Accumulator Removal-Manual Tilt Assist 40 (4 Cylinder), 50/60, 55/60 Sea Pro, 60 Big Foot and Jet 30 & 45

IMPORTANT: This Service Bulletin supercedes all previous instructions.

NOTE: The following procedure replaces the instructions for "Accumulator Removal" in the Service Manual for the above engines and instruction sheet 90-824951 that is supplied with the "Manual Tilt Rate Update Kit".

- a - Cam Lever
b - Screw Plug

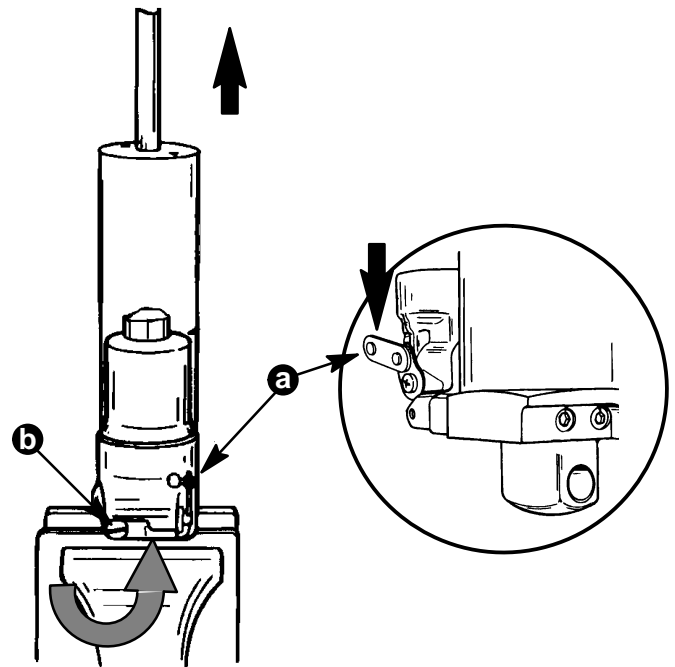
1. Place the manual tilt system in a soft jawed vise. Turn cam lever up.
2. Turn the cam lever to the down position.
3. Extend the tilt ram to full up position.
4. Open the screw plug (counterclockwise) to release the pre-charge pressure.

a - Screw Plug

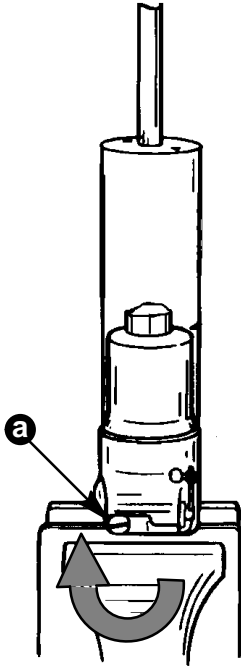
5. Close the screw plug to prevent air from entering the system.

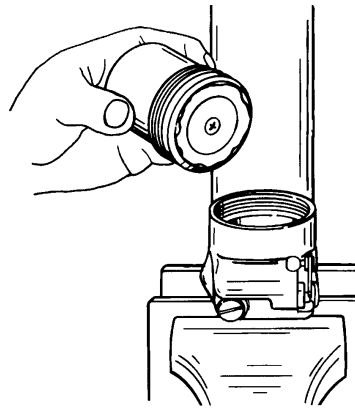
6. Unscrew the accumulator.
